42 RAYMOND Avenue SSD-31552370

Submissions Report

Prepared for HALE CAPITAL 8 July 2022

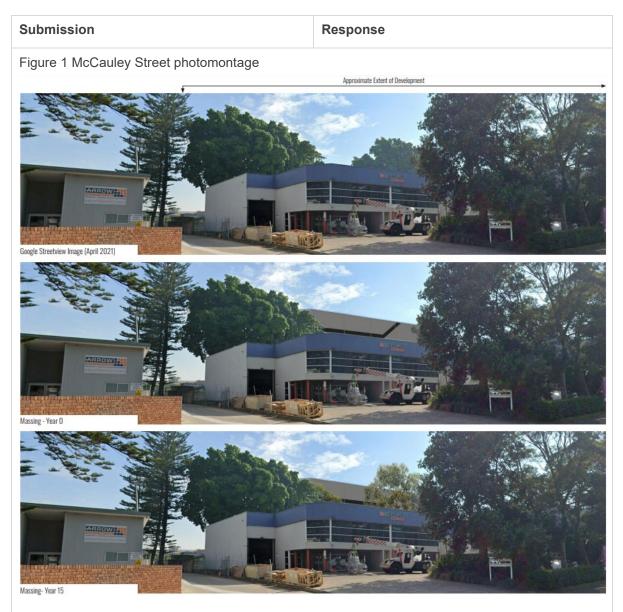
4.3.4. Water Quality	
Given proximity to the Amcor dam to the south greater consideration should be given to the developments impact on these water ways, especially as these drain directly into Botany Bay. As this development is within 40m of a waterfront land Council understands this requires a controlled activity approval may be required under the Water Management Act and greater setbacks from the dam and drainage line should be provided that are greater than those proposed in the landscape plan. There does not appear to have been any consideration of these requirements by the proposal and these need to be considered as they may significantly affect the design layout and landscape design requirements of the proposal.	DPE has confirmed that the <i>Water</i> <i>Management Act</i> does not apply and therefore a controlled activity approval is not required. The Amcor Dam and Bunnerong Channel are not subject to riparian setbacks, therefore the setbacks provided are considered adequate.

Given the location of the Amcor dam adjoining the southwestern boundary of the site and Sydney Water drainage line (Bunnerong Stormwater Channel No 11) on the north- western boundary, greater consideration should be given to the impact on these waterways during operations, especially as these drain directly into Botany Bay. This proposal should include the provision of one-way valve on	Water discharging from the site into the Bunnerong Channel will be treated in accordance with the requirements of Sydney Water. A shut-off valve will be provided to ensure spills are not discharged into the Bunnerong Channel and Botany Bay.
URBIS	22

Submission	Response
stormwater drains into the Bunnerong Canal to enable the valves to be shut off given a spill, leak, or fire incident within the complex. This would contain any pollutants onside and prevent pollutants entering the nearby drainage line and Botany Bay and is best practice for logistics/container storage facilities.	
It is not known whether the subject site is affected by a ground water exclusion zone, Council requests the EIS be updated to clarify whether the subject site is affected by ground water to allow us to adequately assess the impact of the proposal.	The site is located in Area 1 of the "Temporary Water Restriction (Botany Sand Groundwater Source) Order 2018". The order prevents the use of groundwater for domestic purposes and restricts its use for industrial purposes. A Detailed Site Investigation (DSI) has been completed that did not identify any human health risks to the proposed development from groundwater. Additionally, the development does not propose to use groundwater for any purpose (consistent with the 2018 order) and will not alter groundwater flow characteristics at/or adjacent to the site (as no underground structures will be constructed and the site hardstand/cover will remain similar to its current condition). As a result, it is considered that the development will not be impacted by the 2018 order and, if approved, the development will not impact on the presence/distribution of contamination in the aquifer.
